Access Compliance Report

Public Rights-of-Way

(Curb Ramps)

Intersection ID: 31906	Main Street: LAMOILLE_LN	Cross Street: PALOMAR_MOUNTAIN_DR	Location: SW
ADA ID: E776793A002A	Ramp Type: PerpDiag	Initial Pass/Fail: Fail	Overall Compliance: No
Severity Score: 12.5			
Codes/Mitigation Info/Possible Solution		Field Measurements/Component Compliance

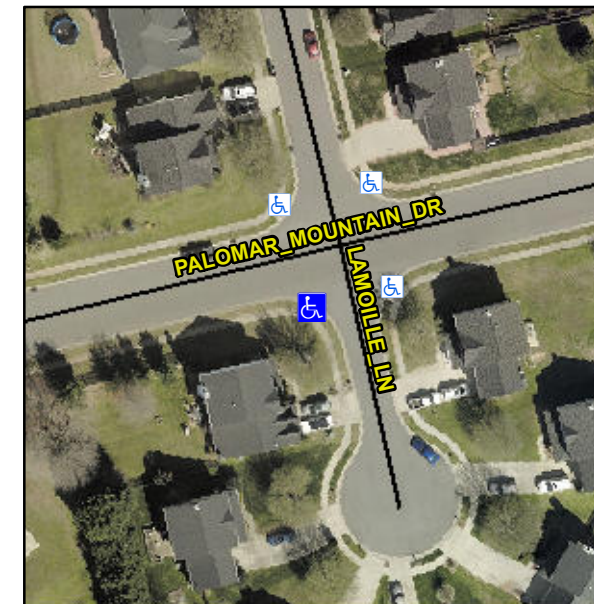
R304.2.2

Compliance	Description	Data	Compliance	Description	Data
N/A	Ramp Length (in)	46.0	No	Ramp Slope (%)	10.2
Yes	Ramp Width (in)	48.0	Yes	Ramp XSlope (%)	0.0
N/A	Flare Type LT	N/A	N/A	Flare Type RT	N/A
N/A	Flare Slope LT (%)	N/A	N/A	Flare Slope RT (%)	N/A
N/A	Flare Traversable LT?	N/A	N/A	Flare Traversable RT?	N/A
N/A	Landing Length (in)	N/A	N/A	DWS Provided?	N/A
N/A	Landing Width (in)	N/A	N/A	DWS Contrast?	N/A
N/A	Landing Slope (%)	N/A	N/A	DWS Length (in)	N/A
N/A	Landing X Slope (%)	N/A	N/A	DWS Full Width?	N/A
N/A	Landing Curb? (Y/N)	N/A	N/A	DWS Offset (in)	N/A
N/A	Shared Landing?	N/A			
N/A	Gutter Ponding?	N/A	N/A	Gutter Slope (%)	N/A
N/A	Gutter Lip Ht (in)	N/A	N/A	Gutter X Slope (%)	N/A
N/A	Painted X Walk1?	No	N/A	Painted X Walk2?	No
	X Walk 1 Direction	To E		X Walk 2 Direction	To N
N/A	X Walk 1 Width (in)	N/A	N/A	X Walk 2 Width (in)	N/A
	X Walk 1 Slope (%)	1.9		X Walk 2 Slope (%)	0.5
	X Walk 1 X Slope (%)	0.7		X Walk 2 X Slope (%)	1.9

Remove & Replace Curb Ramp With Two New Directional Ramps or Equivalent.
